UNITED STATES PATENT AND TRADEMARK OFFICE

Office Action Summary

10/709,886

DETAILED ACTION

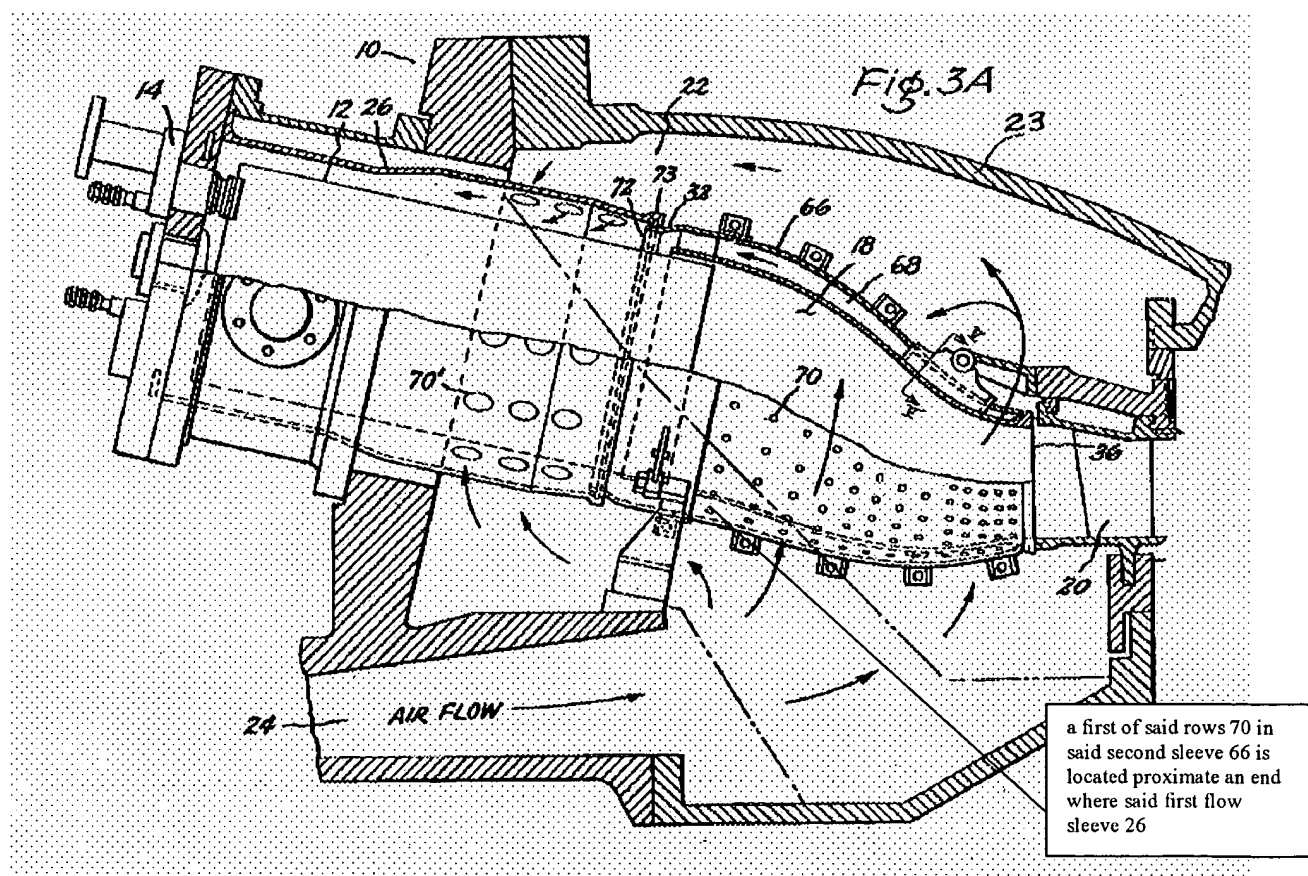
5. Claim 20 is rejected under 35 U.S.C. 102(b) as being anticipated by Davis et al. (US 4,719,748).

Davis teaches a combustor liner of a gas turbine combustor, said combustor liner having a substantially circular cross-section, and a first flow sleeve 26 surrounding said liner in substantially concentric relationship therewith creating a first flow annulus therebetween for

feeding air to the gas turbine combustor, and wherein a transition piece 18 is connected to said combustor liner, with the transition piece surrounded by a second flow sleeve 66, thereby creating a second flow annulus in communication with said first flow annulus, a plurality of axially spaced rows of cooling holes (70', 70) in said flow sleeves, each row extending circumferentially around said flow sleeves, a first of said rows 70 in said second sleeve 66 is located proximate an end where said first flow sleeve 26 and said second flow sleeve 66 interface, wherein cooling air is supplied to said cooling holes (70, 70'). Since **Davis** has the same structure as claimed, it is inherent that **Davis's** device would be able to perform the recited method steps. See particularly **Figure 3a** of **Davis** above.

Figures 8 & 10 of Maeda

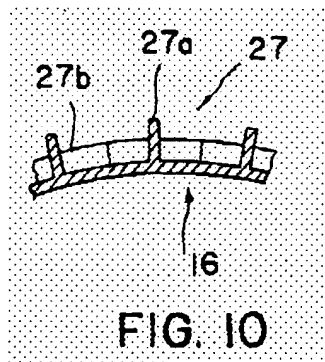
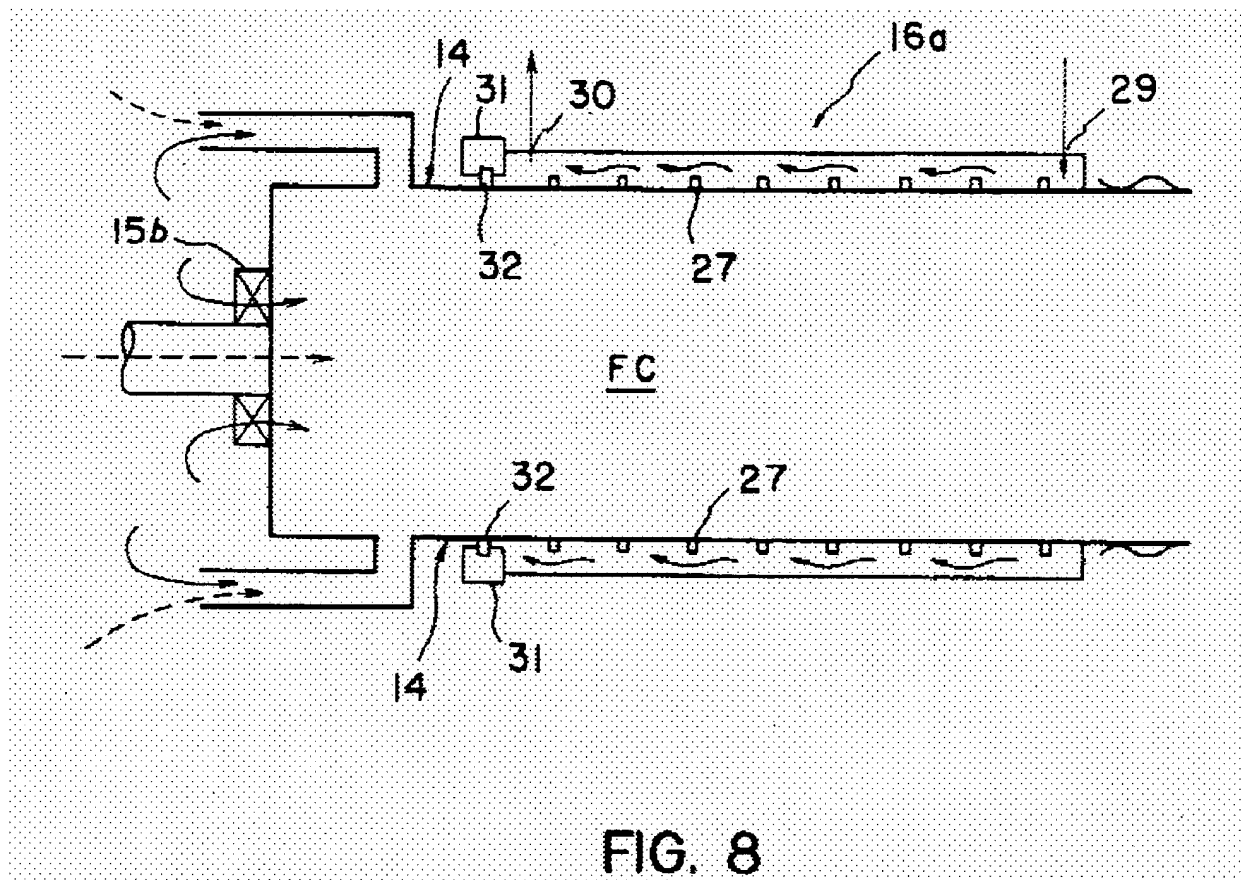
7. Claim 21 is rejected under 35 U.S.C. 103(a) as being unpatentable over **Davis et al.** (US 4,719,748) in view of **Maeda** (US 5,802,841).

Davis does not teach a plurality of discrete ring turbulators arranged in spaced relationship on said outer surface of said combustor liner. However, **Maeda** teaches a combustor liner having plurality of discrete ring turbulators 27 arranged in spaced relationship on said outer surface of said combustor liner, wherein said turbulators serve to disrupt the flow on the liner surface in a manner that enhances heat transfer, thus improving the cooling performance of the combustor liner and increasing its operating life (column 9 lines 45-59 of Maeda). Therefore, it would have been obvious to one of ordinary skill in the art at the time the invention was made to have provided Davis combustion liner with Maeda's turbulators in order

to effectively cool the combustor liner by enhancing heat extraction through disruption of the flow on the liner surface and increase its operating life. See particularly **Figures 8 and 10** of Maeda.
